Permit Type Building/Residential/Misc/Tanks	Permit Number B25001792	Opened Date 05/07/2025
Description of Work FDP/ INSTALL (1) 1000GAL UNDERGROUND PROPANE TANK

Permit Type	Permit Number	Opened Date
Building/Residential/New/SFD	B25000055	01/07/2025
Description of Work		
SFD/ MODEL "DORCHESTER IV", 2 STORY, Full Basement, Basement = Partially Finished, 15R, 5FB, 1HB, 1FP, 3 Car Attached, 5BR, N/A, ENERGY METHOD = Prescriptive Method, null.OPTIONAL SMALL MORNING ROOM FINISHED LOWER LEVEL REC RM, STUDY AND FINISHED SPACE UNDER MORNING ROOM, SEE EXTENSIONS IN DESCRIPTION OF WORK

From: Oswald Jr, Woodin
Sent: Thursday, January 23, 2025 7:28 AM
To: Marina Morris
Subject: RE: B25000055_12950 Highland Road_Floor Plan Concern

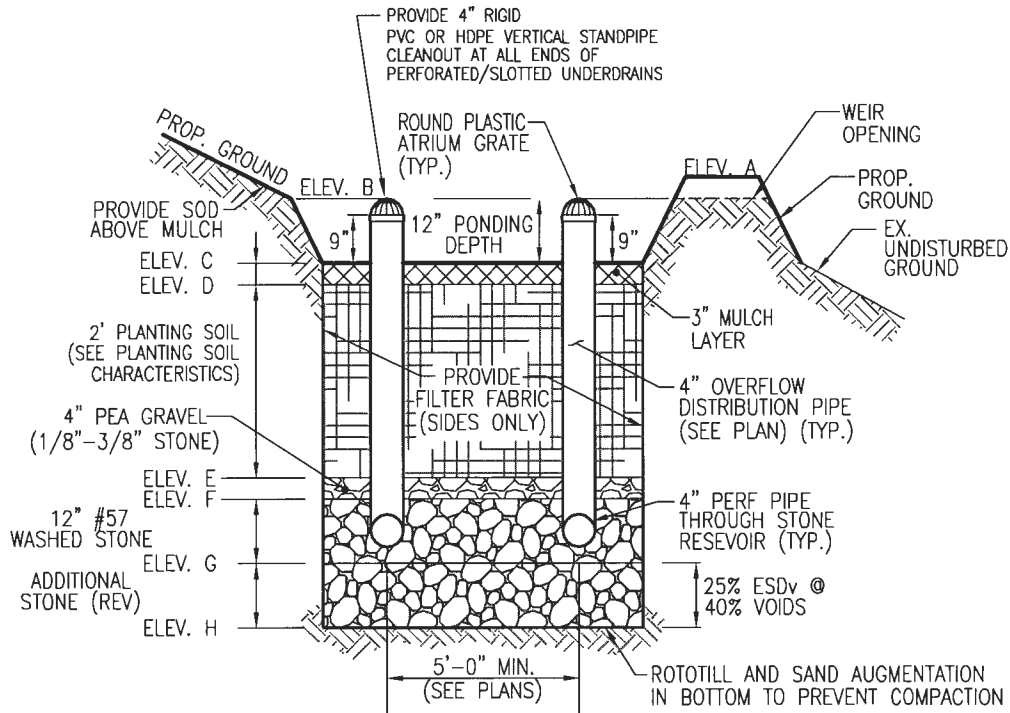
Under the definition (see attached), the room has to be 90 sq. ft. or greater, may be used as a private sleeping area, and has at least one window and one interior door.

The room labeled "study" in the basement also meets the definition of a bedroom.

Good morning. I reviewed the floor plans for 12950 Highland Road, and the bedroom count is currently at 6 (not including the "media" room in the basement). Is the media room in the basement unconditioned space? It reads "unfinished" on the floor plan.

Upon finishing the media room, it would meet the definition of a bedroom and this would increase the bedroom count to 7. However, prior to finishing the media room under a separate building permit, the Health Dept would require septic system upgrades. Do you want to check with the engineer about increasing the capacity of the septic system now? This would involve revising the already approved OSDS Plan and submitting it for review/approval.

If you'd rather move forward without making any changes to the OSDS Plan, then I will need to issue the basement bedroom memo. Do you already have a buyer for this property? I would like to copy them on this memo. Do you have their email address? I would also like the description of work on the building permit updated to state that the media room will remain unfinished under this building permit.

Good morning. Thank for the updated floor plan. I also saw the revised floor plan in the system. This is sufficient to approve the building permit.

I am attaching a copy of the basement with the window crossed off. I have also sent this to George Martin. Let me know if there is something else I need to do.
Thanks in advance.

I have figured out where we went wrong with this. There is no window in the unfinished media room. You can see it on the unfinished basement drawing (page 2). The finished basement drawing has an **optional** window in the media room. What do I need to do to correct this? I really just need to cross out the optional window. It's an inground basement. Your help would be appreciated. This way, we won't have to send an email out to the buyers.
